<u>Subject</u>: First Comments on the Department of Energy's *Tucson Electric Power Company (TEP) Sahuarita-Nogales Transmission Line Draft Environmental Impact Statement* (DOE/EIS-0336 and BLM Reference No. AZA 31746) dated July 2003

Magruder - First Comments on TEP Transmission Line Draft EIS dated October 14, 2003

Part I - Specific Comments, Questions, and Recommendations on the Draft EIS (July 2003 version)

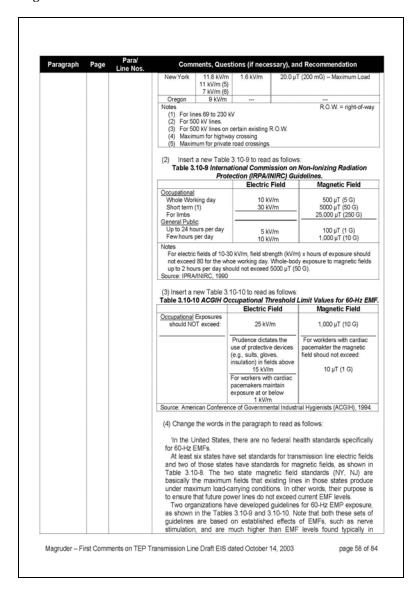
EMF Field Level of Some Common House Hold Appliances		(entire)	At 340 feet (10. 353. Comm report dat internal gi appliance from a stu. and their lines is ve since app EMF. 354. Quest from mod 355. Recor 356. Comm EMF. The the electri Further, A micro Tess childhood boundary magnetic respect to 357. Recor (1) Insert a	4 meters) ment. The refered Septembe red Septembe red Septembe rounding, RF is in the past in the rew reariability. The rew	or 1985. There is 1985. The restriction and 18 or so years which ding and 18 or so years or so years of the restriction of the	to 20% ut (0.76 ut (0	eman man man man man man man man man man	0.006 kV/m e that is a ments in from such blowing Ta appliances transmissi n argumen n respect to iscuss EMI used for the limit fo amps (rms) of 3 mG (0 i with ine the e electric a sion with
EMF Field Level of Some Common House Hold Appliances		(entire)	At 340 feet (10. 353. Comm report dat internal gi appliance from a st. and their ilines is ve since app EMF. 354. Quest from mod 355. Recor 356. Comm EMF. The the electri Further, A micro Tes childhood boundary magnetic respect to 357. Recor (1) Insert a Table 3.10	4 meters) ment. The refe ed Septembe rounding, RF is in the past in in the rewo variability. The rewo variability. The rewo variability. The pendit of the repliance ment. This pa rere is the Natio to field under the ppendit R, p plaasa saw then leukemia. Th of the require field values to other state is mmendations new Table 3.0 -8 State Tran Electri	ir 1985. There ir 1985. There is shielding and 18 or so year orded paragra e connection, not true, no mmoral, not true, no mmoral, not 200E have bette is 2 This table is 72 This table is 72 This table is 1970 and 1970 a	to 20% ut (0.76 ut (0	IS m(S) IS m(S) IS m(S) Improve diations if my	0.006 kV/m 0.006 kV/m e that is a ments in from such billowing Ta appliances transmissin a argument n respect to liscuss EMI used for the limit fo amps (rms) of 3 mG (0 with limit fo amps (rms) of 3 mG (0 with limit fo amps (rms) of 3 mG (0 with limit fo amps (rms) of 3 mG (0 with limit fo amps (rms) of 3 mG (0 with limit fo amps (rms) of 3 mG (0 with limit fo amps (rms) of 3 mG (0 with limit for a with limi

The reference for the data for Table 3.10-1, EMF Level of Some Common Household Appliances, in the EIS was from a study done in 2003, and not September 1985 as stated by the commentor.

The comparison with the household appliance EMF was used for exposure to EMF from the transmission line because exposure to EMF from the transmission line would not be continuous, as there are no houses located in the vicinity of the proposed corridors that would be exposed to continuous EMF from the transmission line. Therefore, like exposures the household appliance EMF, exposure to EMF from the transmission line would be short-term.
